V2500-A5 SERIES PROPULSION SYSTEMS SERVICE BULLETIN

V2500-NAC-71-0312

NACELLE - POWERPLANT - DRAIN SYSTEM - REROUTING OF THE HYDRAULIC PUMP DRAIN TUBES1. Planning InformationA. Effectivity

Rerouting of the Hydraulic Drains Tube Assembly
Figure 1 (Sheet 1 of 3)

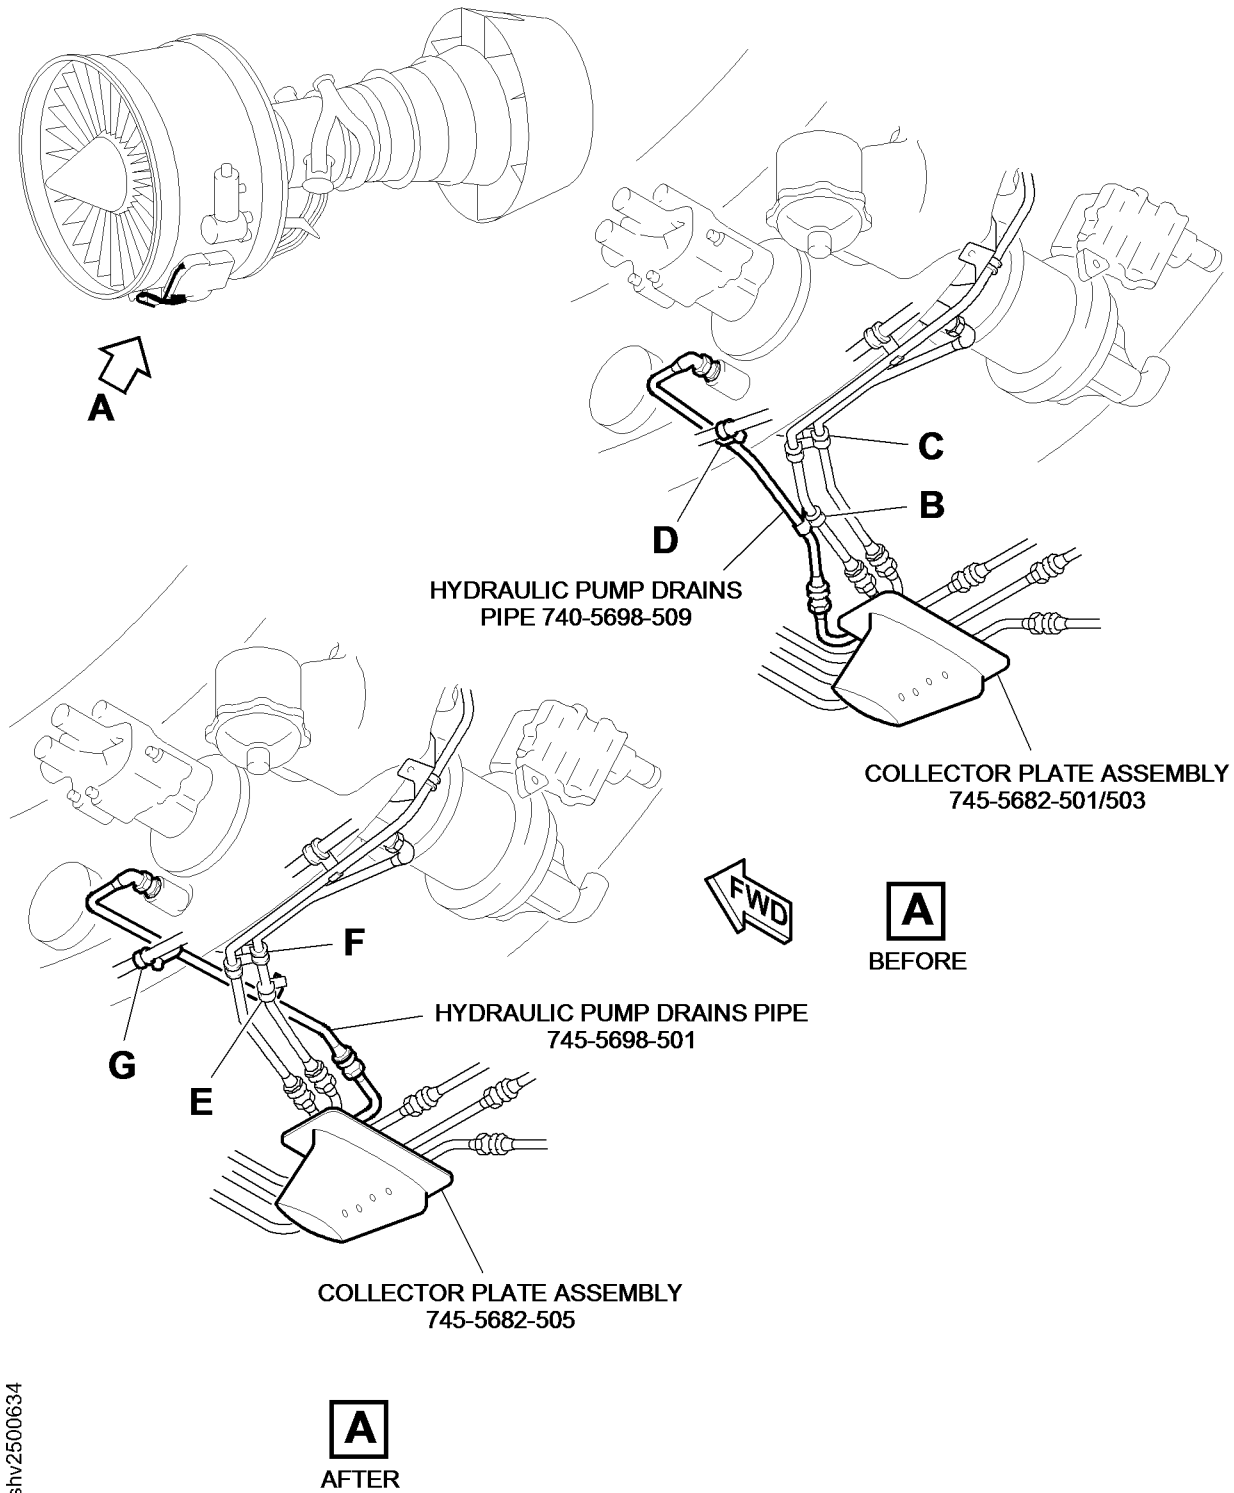
The anti-swivel plate on the right hand fan cowl door no. 3 latch may chafe with the hydraulic pump drains pipe.

An operator has reported damage to the hydraulic pump drains pipe. Upon investigation, it was discovered that there may be less than minimum clearance between the no. 3 latch anti-swivel plate on the right hand fan cowl door and the hydraulic pump drains pipe.

The new hydraulic pump drains routing will improve clearance between the pipe assembly and the no. 3 latch anti swivel plate on the right hand fan cowl door.

The collector plate assembly and the hydraulic pump drains pipe assembly will be removed. A new collector plate assembly and the hydraulic pump drains pipe assembly, with revised routing, will be installed. Clipping points CP0942 and CP0959 will be amended. Clipping point CP0943 will be deleted and a new clipping point CP1491 will be introduced.

- (1) At clipping point CP0943, remove the nut AS20624, the washer SP154D and the bolt AS21408 to release the p-clip 400WSS6 from the tube assembly the 740-5673-503 (Refer to Figure 1, view B).

- (2) At clipping point CP0943, remove the p-clip 400WSS6 from the 740-5673-503 tube assembly.
- (3) At clipping point CP0942, remove the bolt AS21411 or AS21415 and the spacer ST1698D47 or ST1698D48 to release the tube assembly 740-5702-509 and tube assembly 740-5673-503 from the bracket 740-5640-503 (Refer to Figure 1, view C).

- (4) At clipping point CP0942, remove the p-clip 400WSS4 from the tube assembly 740-5702-509 and the p-clip 400WSS6 from the tube assembly 740-5640-503.

- (5) At clipping point CP0959, remove the nut AS20624, the washer SP154D and the bolt AS21408 to release the p-clip 400WSS8 from the fan case fire detector (Refer to Figure 1, view D).

- (6) At clipping point CP0959, remove the p-clip 400WSS8 from the fan case fire detector.
- (7) Remove the collector plate 745-5682-501 or 745-5682-503 from the aircraft as instructed in the Aircraft Maintenance Manual, Chapter 71-71-42-000-010 (Refer to Figure 1, sheet 1).

- (8) Disconnect the hydraulic drain tube 740-5698-509 from the hydraulic pump union (Refer to Figure 1).

- (10) Install the collector plate 745-5682-505 to the aircraft (Refer to the Aircraft Maintenance Manual, Chapter 71-71-42-400-010).
- (11) At clipping point CP1491, fit the p-clip 400WSS4 on the tube assembly 740-5702-509 and secure to the drains tube assembly 745-5698-501 with the bolt AS21408, the washer SP154D and the nut AS20624 (Refer to Figure 1, view E).

- (12) At clipping point CP0942, fit the p-clip 400WSS4 on the tube assembly 740-5702-509 and the p-clip 400WSS6 on the tube assembly 740-5673-503 and secure to the bracket 740-5640-503 with the bolt AS21415 and the two spacers ST1698D47 (Refer to Figure 1, view F).

- (13) At clipping point CP0959, fit the p-clip 400WSS8 on the fan case fire detector and secure to the drains tube assembly 745-5698-501 with the bolt AS21408, the washer SP154D and the nut AS20624 (Refer to Figure 1, view G).

- (17) At clipping point CP0942, torque the bolt AS21415 to 36 - 44 lbfin (4,07 - 4,97 Nm) (Refer to the Standard Practices Manual, Chapter 70-41-00).
- (18) Check for a minimum clearance of 0.25 in. (6,35 mm) between the drains tube assembly 745-5698-501 and adjacent hardware.
